USB Power Delivery ENGINEERING CHANGE NOTICE

Title: Removing the usage of Ping Message

Applied to: USB Power Delivery Specification Revision 3.2

Version 1.0

(e). Figure 6-60

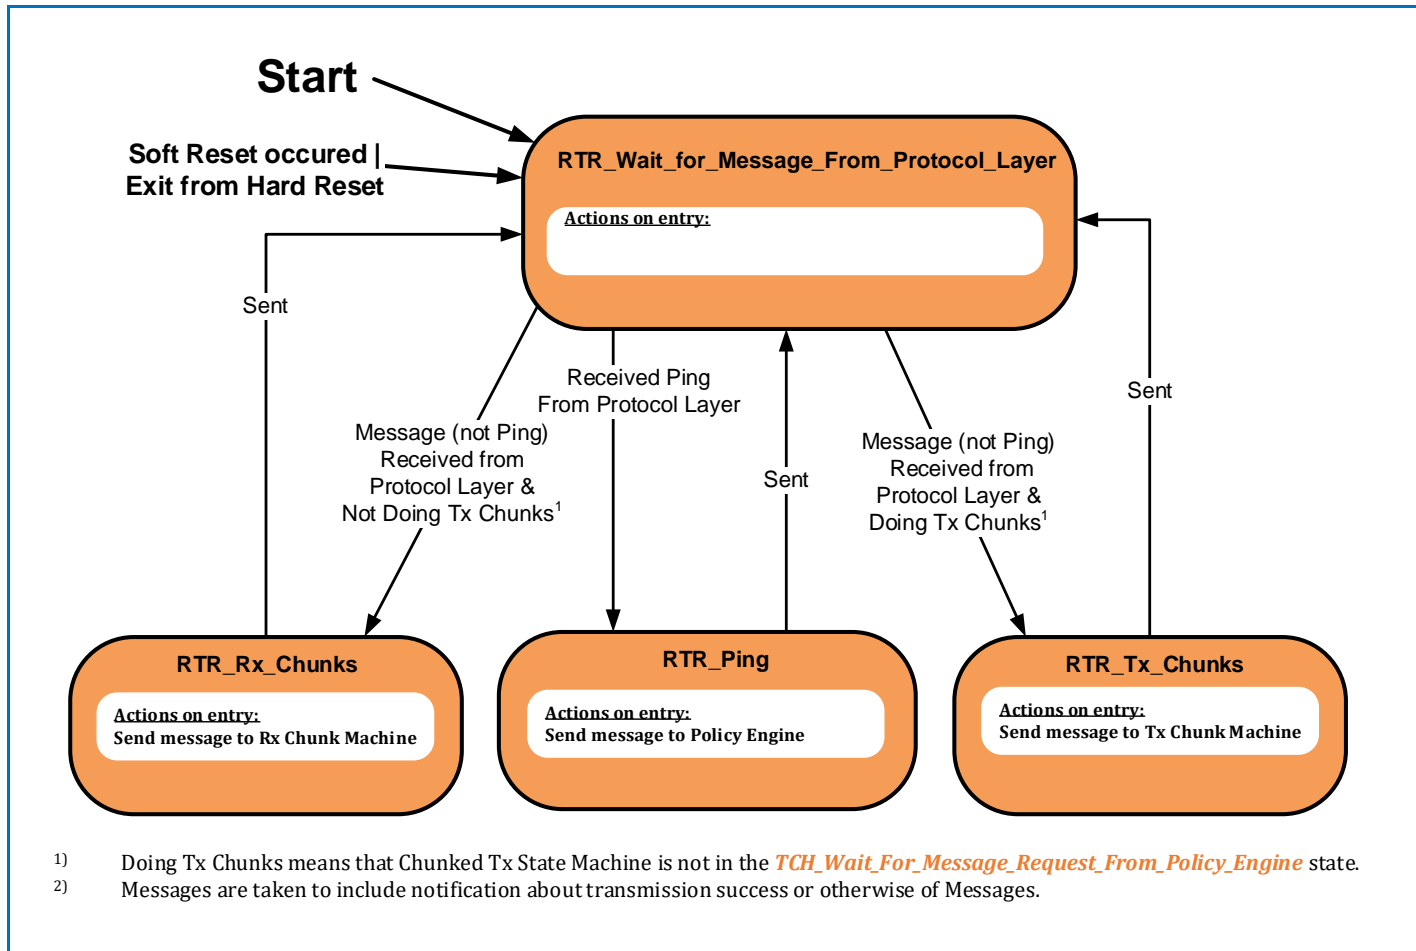
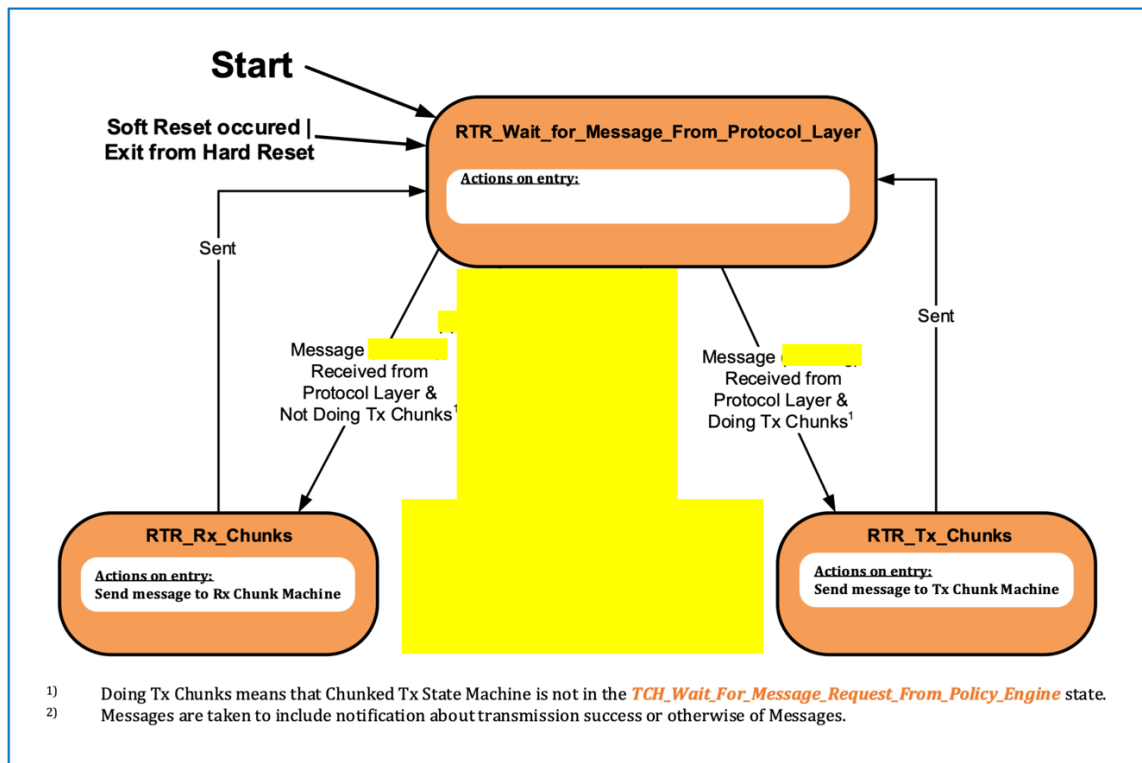
Ping messages were used in PD1 to verify that the Sink is still connected. It has no significance in PD2 and newer versions.

Removing a number of requirements that complicate both HW and SW implementations.
